CERTIFICATE OF APPROPRIATENESS

Property: 125 Payne Street, Tract 18, Block 31, Grota Home Subdivision. The property includes a historic 2,430 square foot, one-story wood frame single-family residence situated on a 5,000 square foot (50' x 100') interior lot.

Proposal: Alteration – Construct a one car garage and pergola that will be attached to the rear corner of the house.

HAHC Action: Approved with Conditions: Detach the pergola and garage from the existing structure.

SITE PLAN

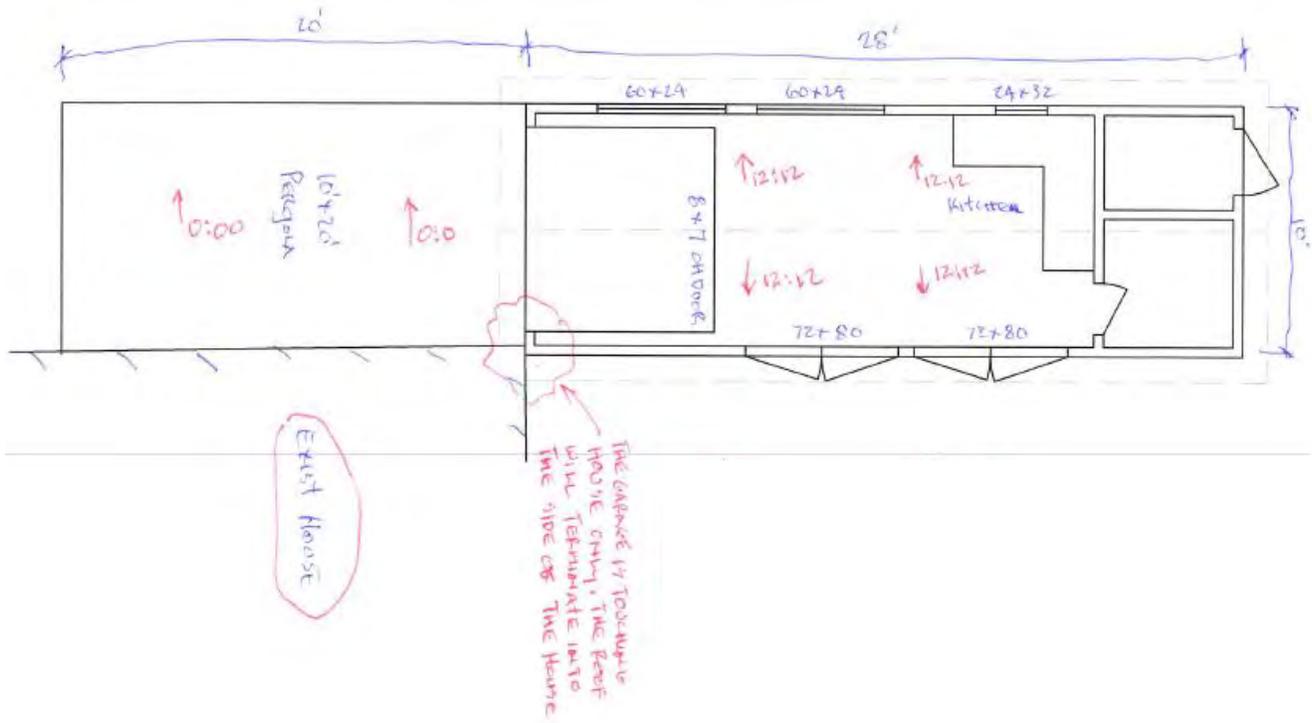
<i>The proposed addition does not retain and preserve the historical character of the property due to improper massing and garage location. While the garage is located on the rear half of the lot, the abutting of the proposed garage to the existing structure is incompatible compared to other structures within the district.</i></p> |

<i>The proposed alteration is incompatible with the massing and character of the property as well as the district. The attachment of the garage and pergola is an incompatible massing compared to historic structures within the district. Attaching the garage to the corner is incompatible and is not a feature of other garages within the district. If the garage and pergola are detached approval would be recommended.</i></p> |

Recommendation: Approval with conditions: Detach the pergola and garage from the existing structure.

PERGOLA CONNECTION DETAIL

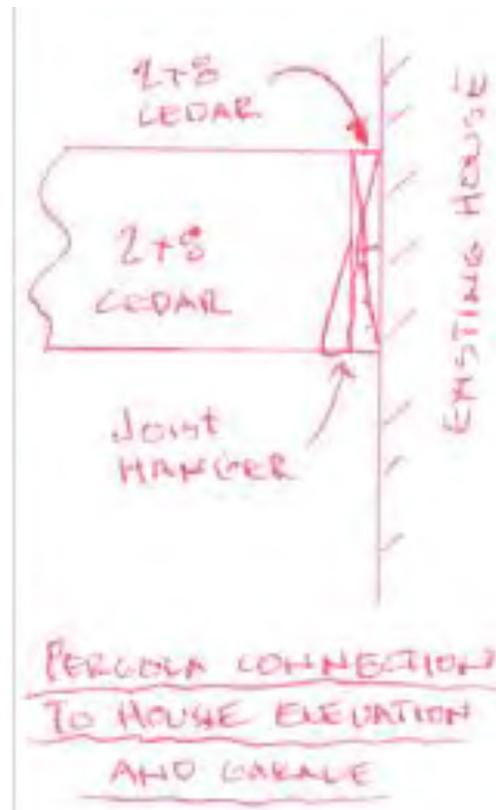
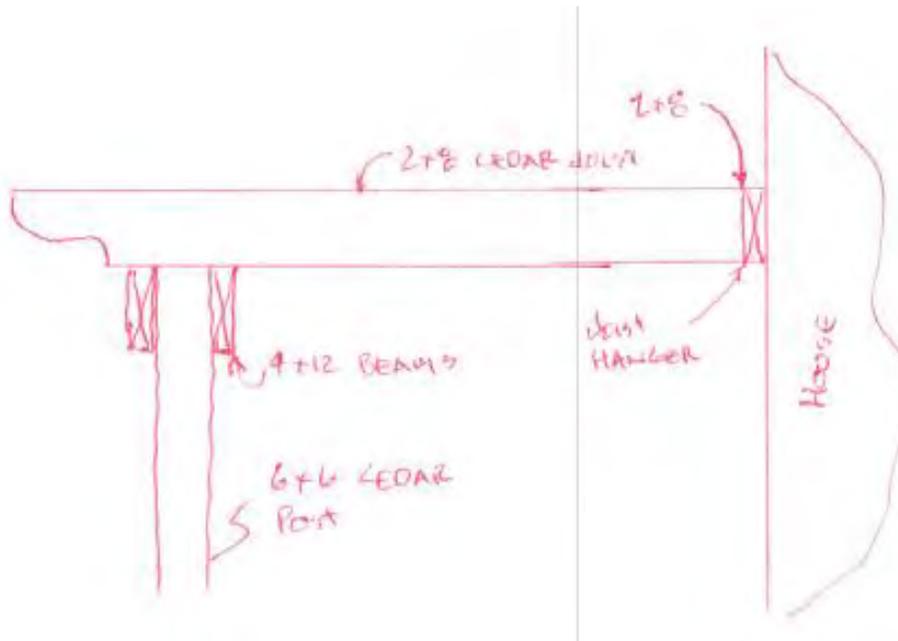
<i>Attaching the pergola into the existing structure will destroy portions of original siding. If the pergola is detached from the existing structure approval would be recommended.</i></p> |
